C L E P A

Proposal for an additional measuring device drawing for shield systems

64th meeting of the UN Informal Group on CRS

ECE/TRANS/WP.29/GRSP/2017/xx

Figure 1.

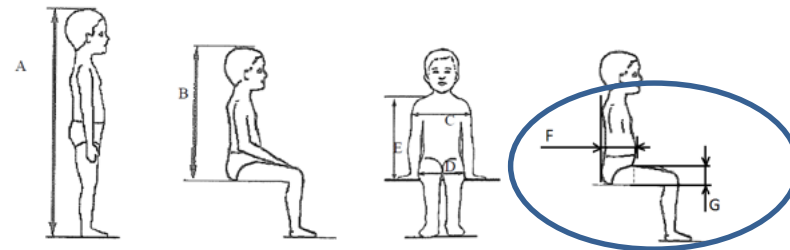
- CLEPA proposal on shield systems includes new internal dimensions (.../GRSP/2017/15&16)

Annex 18, amend to read: |

Figure 3: (PROPOSED)

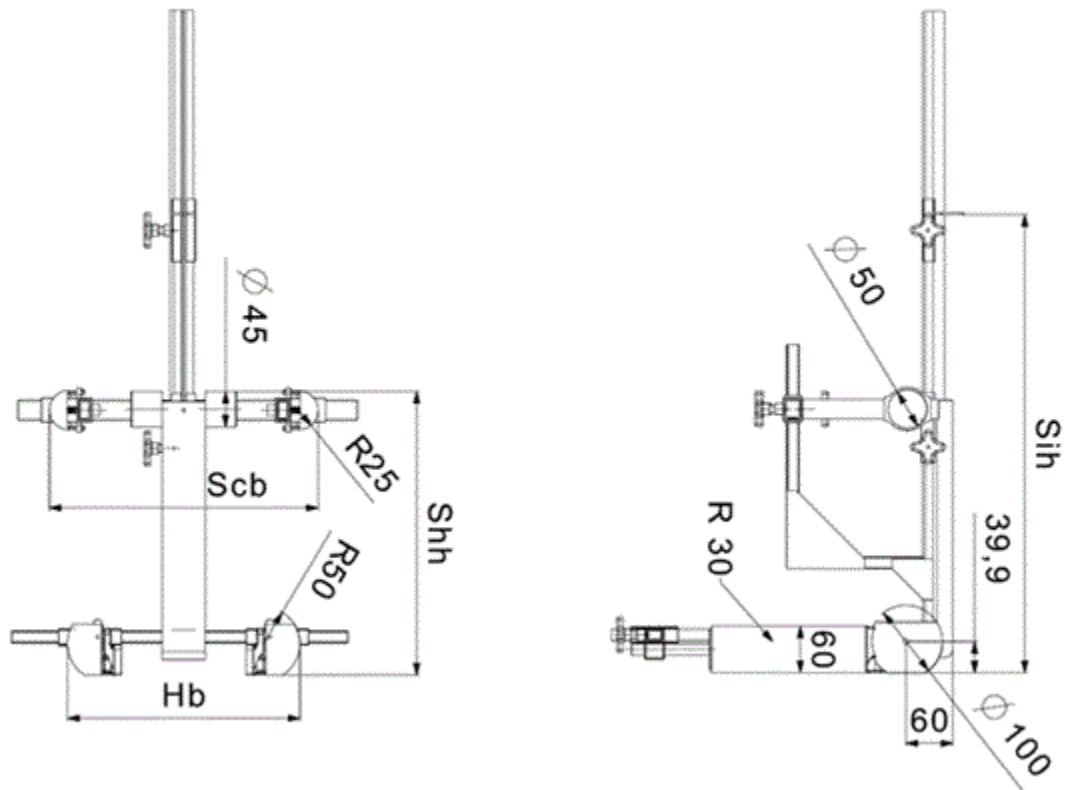
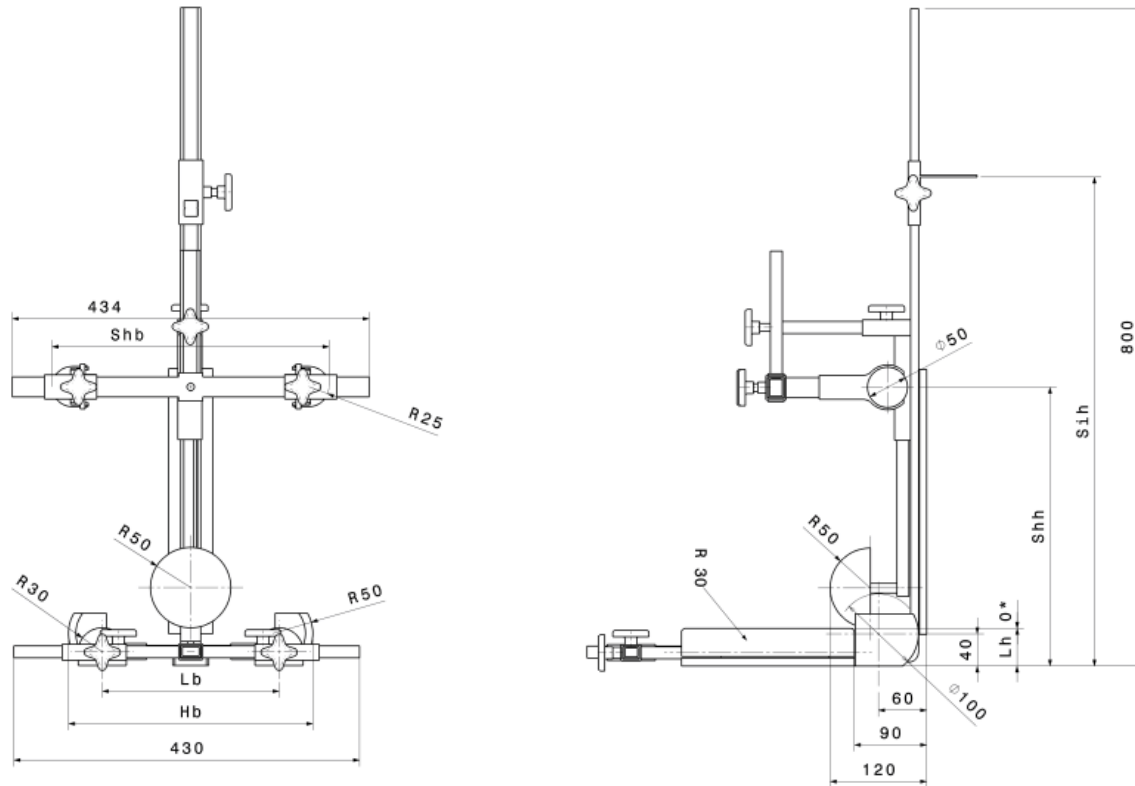
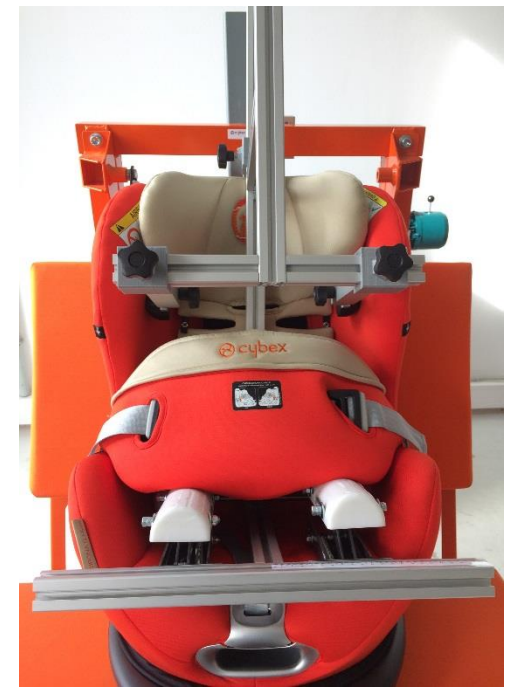
- New measuring device drawings needed to complete the proposal

- To specify new drawings consistent in style and detail to those in Figure 2 of Annex 18:
